NOTICE OF DECISION

CLASS 3 SITE PLAN REVIEW / CLASS 2 ADJUSTMENT / CLASS 2 DRIVEWAY APPROACH PERMIT CASE NO. SPR-ADJ-DAP17-26

SUMMARY: Proposed redevelopment of existing property, including removing existing buildings and development of three new retail/office buildings and parking area.

**SITE PLAN REVIEW, ADJUSTMENT, AND DRIVEWAY APPROACH PERMIT
CASE NO. SPR-ADJ-DAP17-26
DECISION**

1 OVERALL SITE PLAN
SCALE: 1" = 30'-0"

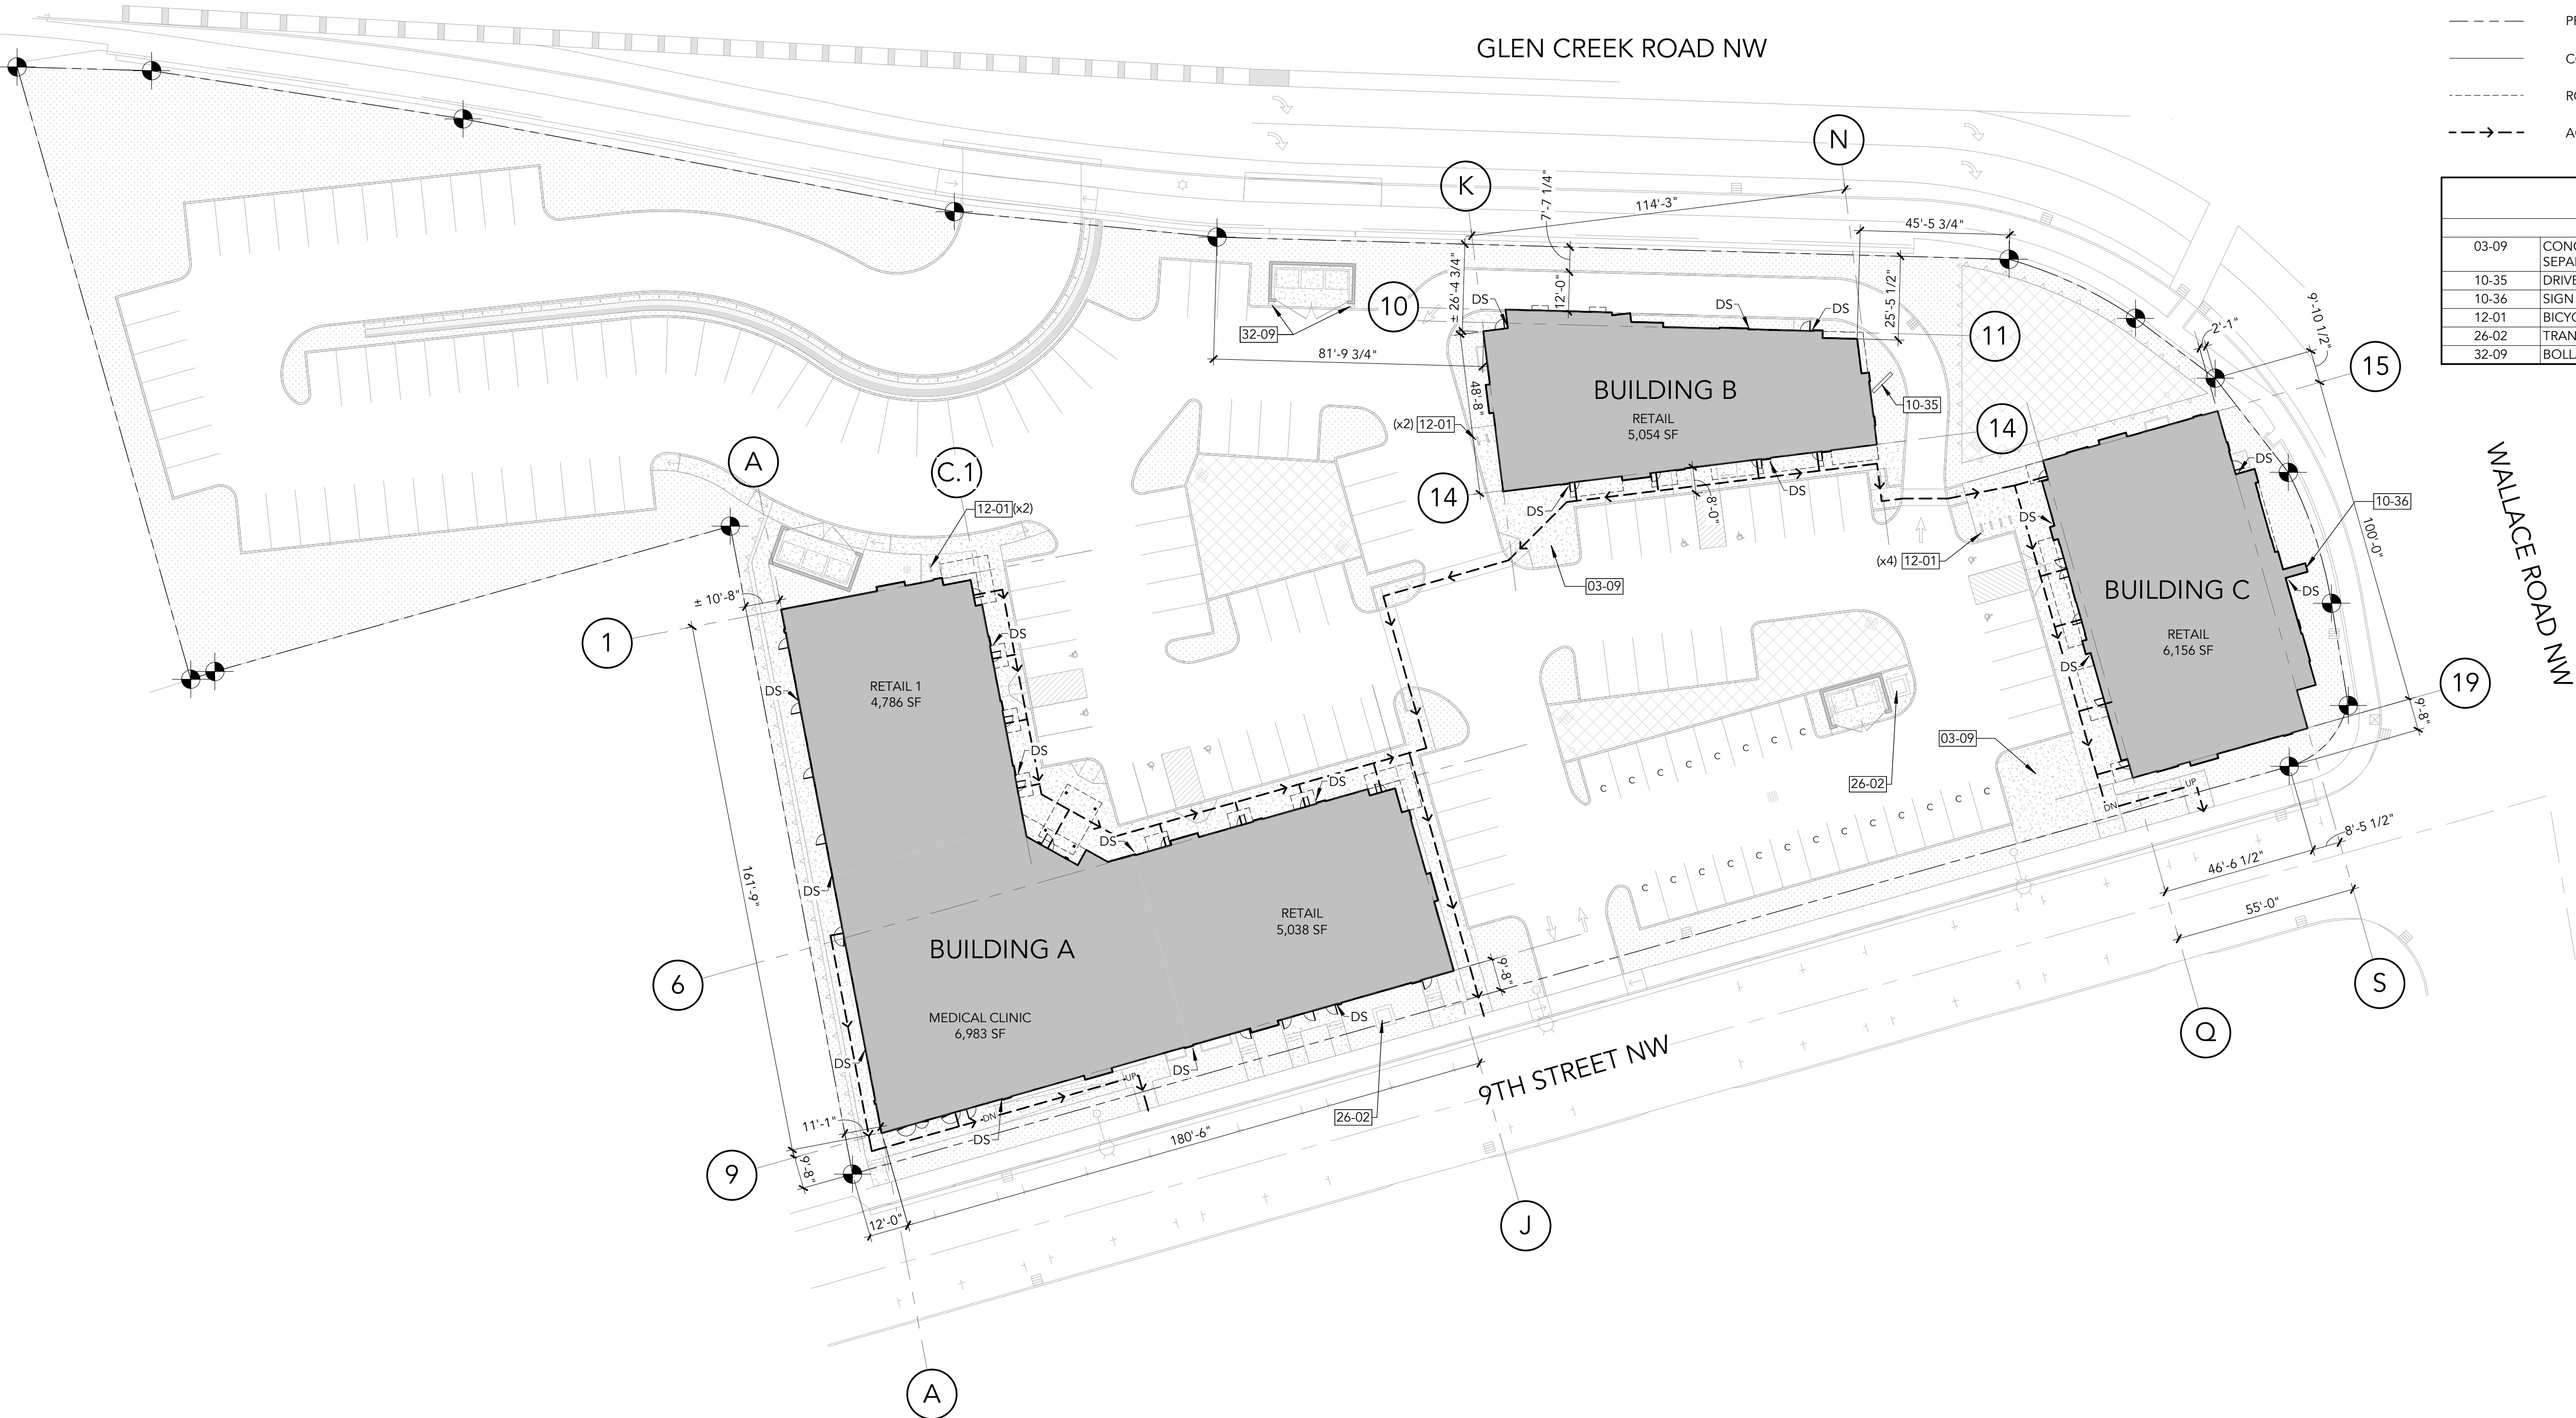
Finding: The proposed site plan indicates that bicycle parking spaces will be provided near the entrance for proposed buildings A and C, however the proposed bicycle parking location for Building B is not visible from a primary building entrance and will need to be relocated.

Condition 1: Bicycle parking spaces for Building B shall be relocated so it is clearly visible from the primary building entrance. In no event shall the bicycle parking spaces be located more than 50 feet from the primary building entrance.

DEACON DEVELOPMENT
THE POINTE AT GLEN CREEK
UTILITY PLAN

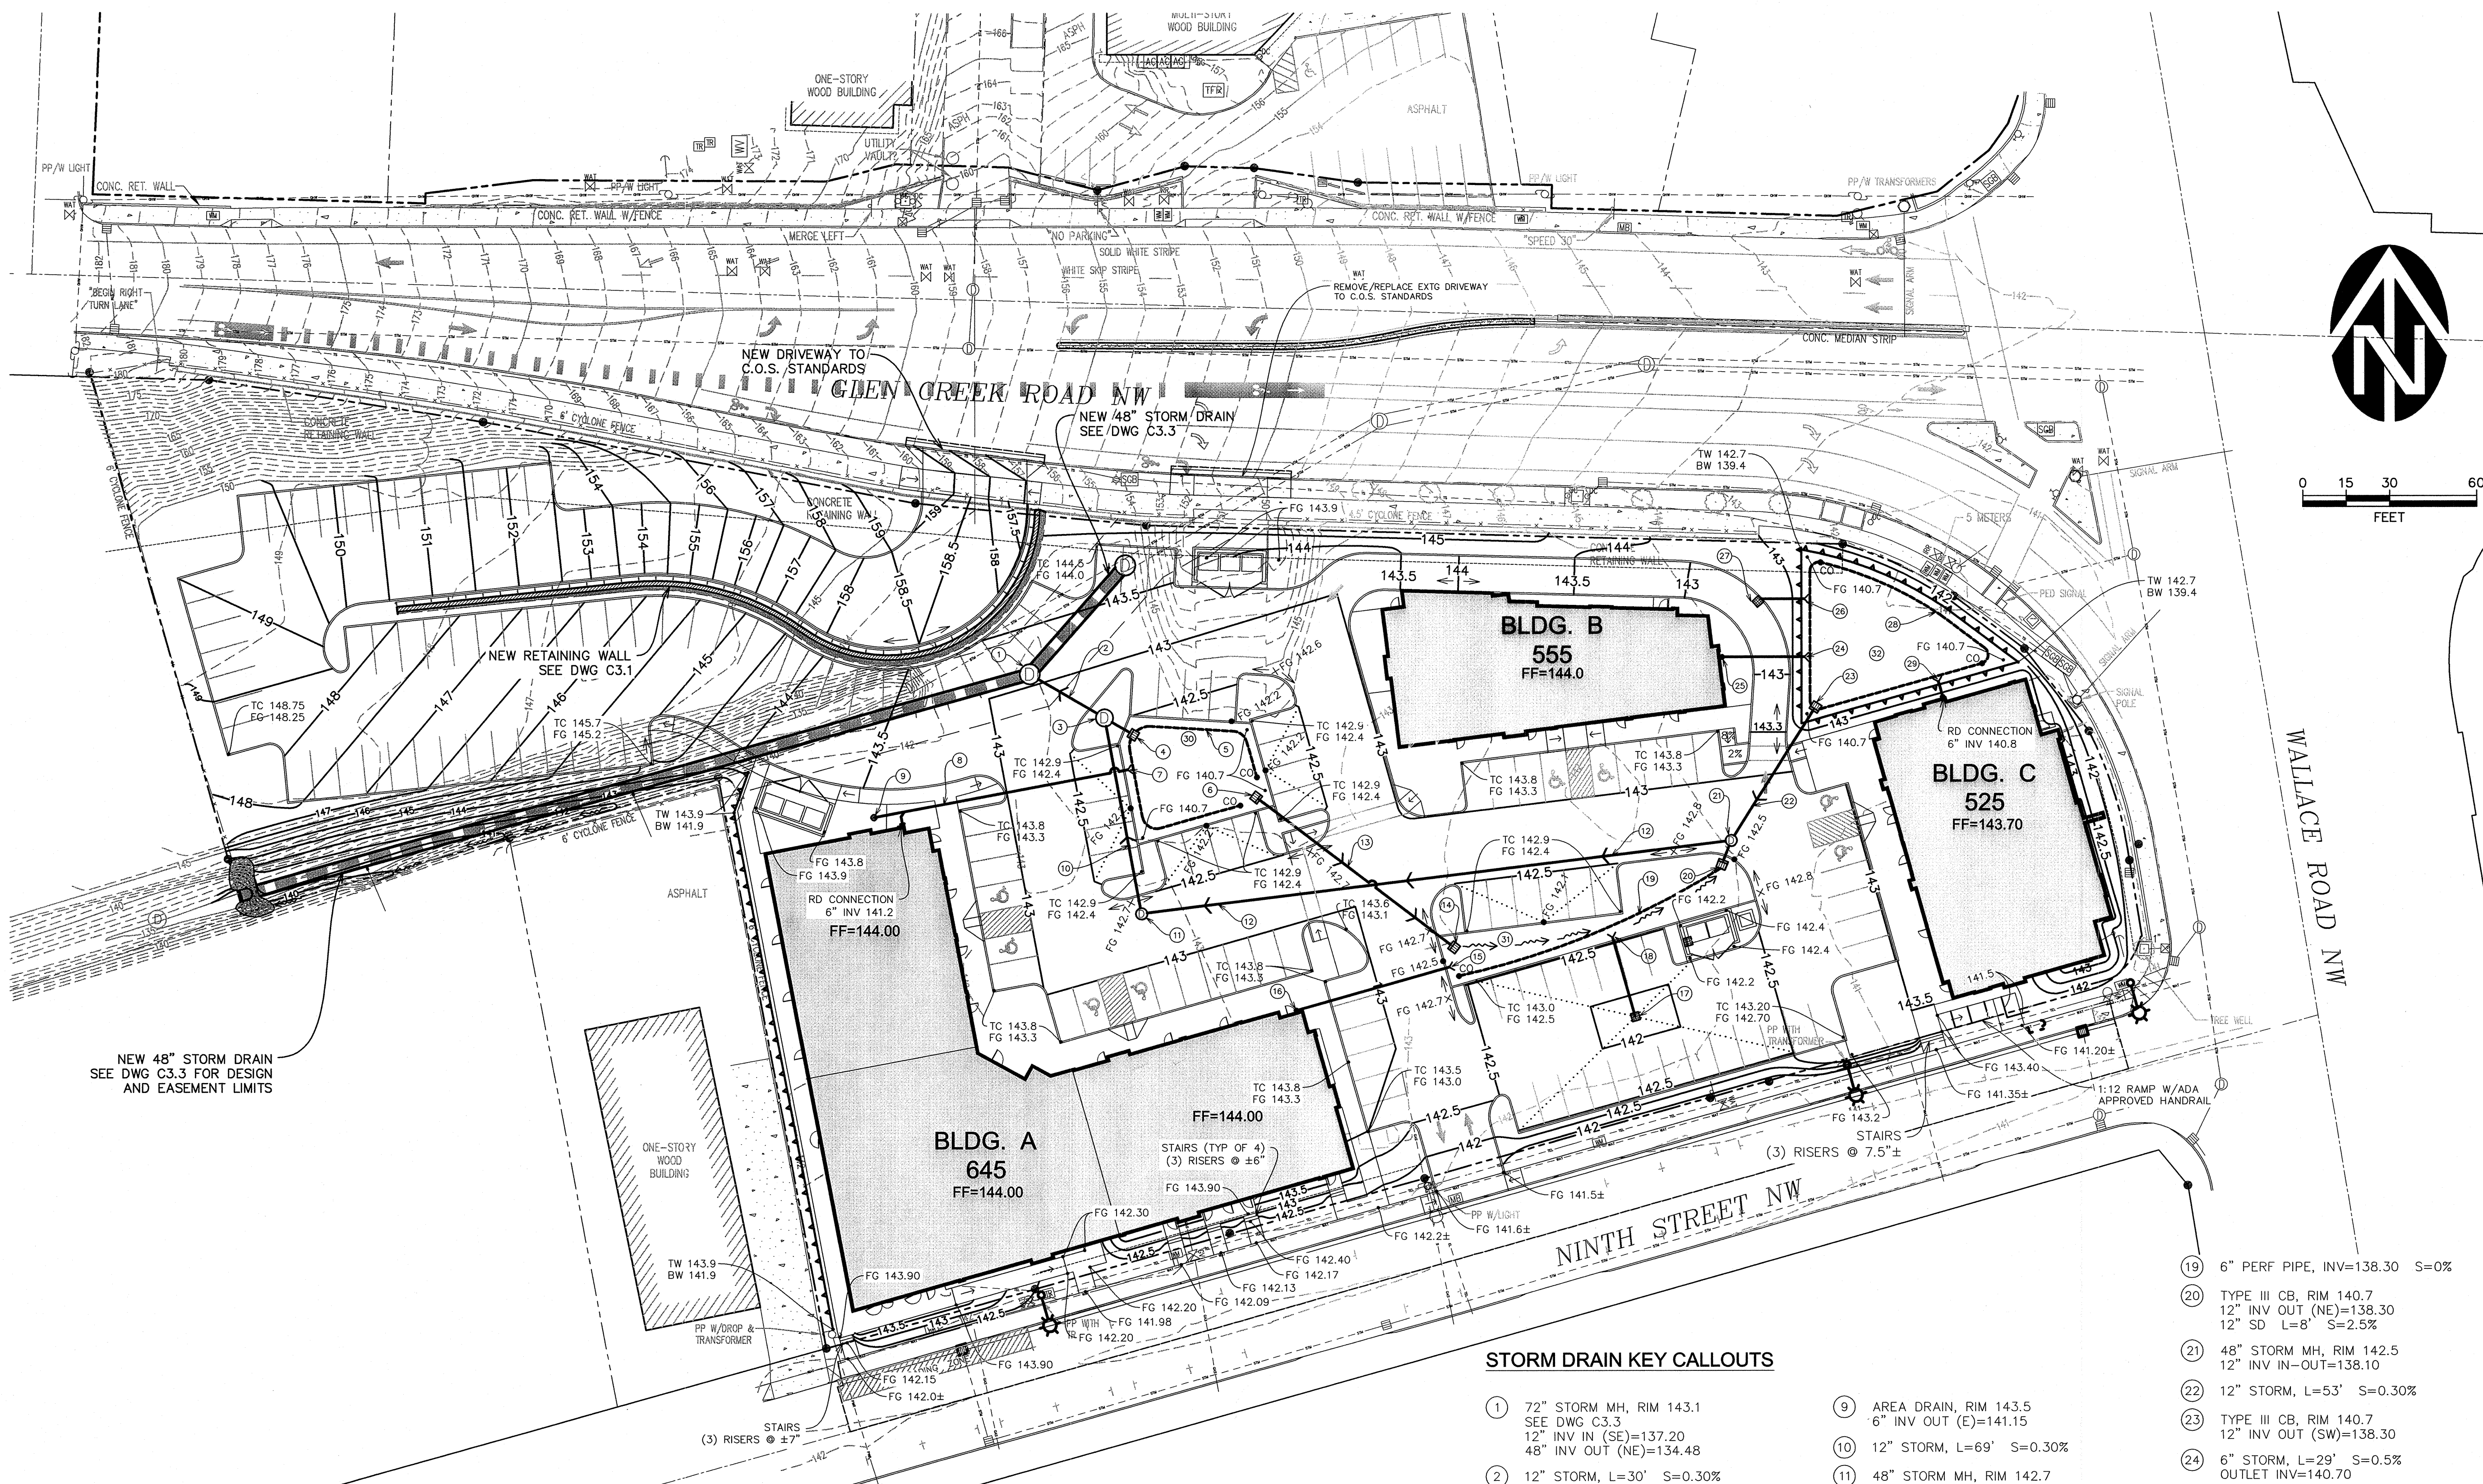
Finding: The Public Works Department has reviewed the applicant's preliminary utility plan for this site. The water, sewer, and storm infrastructure are available within surrounding streets / areas and appear to be adequate to serve the proposed development. The applicant shall design and construct all utilities (sewer, water, and storm drainage) according to the PWDS and to the satisfaction of the Public Works Director. As specified in the conditions of approval, the applicant shall dedicate a 25-foot public storm easement along the full length of the proposed 48-inch storm main extension at the northwest corner of the subject property. Acquisition of an easement from the neighboring property owner may be required to meet the minimum easement width of 25 feet unless modified under a design exception by the City Engineer.

- Condition 4:** Dedicate a 25-foot public storm easement along the full length of the proposed 48-inch storm main extension pursuant to PWDS. Acquisition of an easement from the neighboring property owner may be required to meet the minimum easement width of 25 feet unless modified under a design exception by the City engineer.
